## Product Change Notice

Issue Date: 13-December-2021

0.56" Dual Digit Scrambler poles modification for Leadframe Seven Segment Display

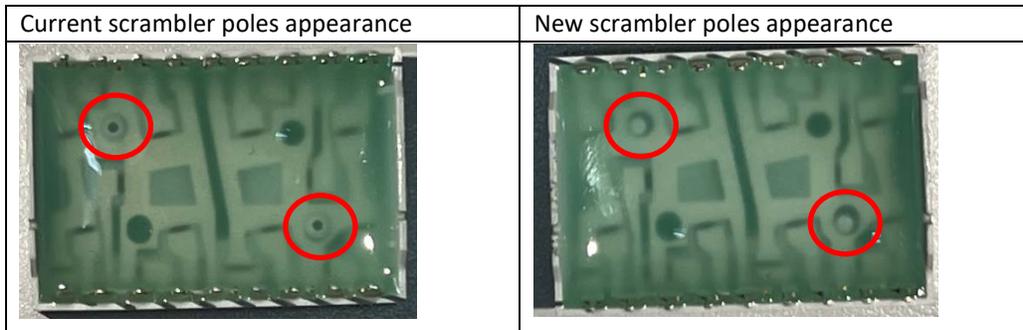
The new scrambler will replace current scrambler for part numbers above.

Improve the strength of scrambler poles.

There is no change in fit and function of the product as per datasheet. However, there is a minor scrambler poles appearance change as illustrated below.
